## PROBLEM:

## CORRECTION:

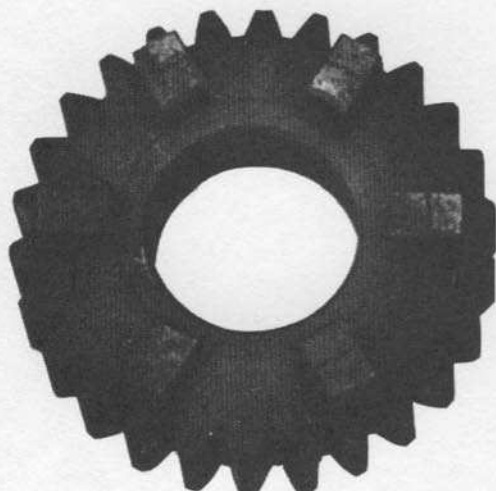
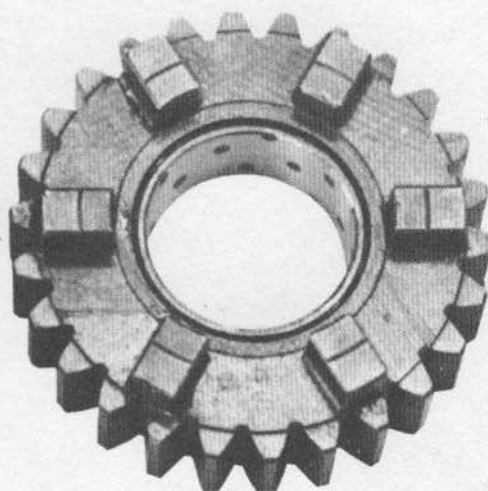
In the transmissions of H1 models there is a possibility for unusually fast wear on the inside of top gear on the drive shaft. As the gear wears, it begins to wobble on the shaft, eventually causing serious trouble in the transmission.

To eliminate this possibility, top gear on the drive shaft has been changed. The new gear is made with a pressed in bronze bushing for extended life. This change has been applied to all H1's in production from frame number KAF-57161, and to all H2's from beginning of production.

Top Gear  
(No Bushing)  
P/N 13136-022

Top Gear  
Bronze Bushing  
P/N 13136-041
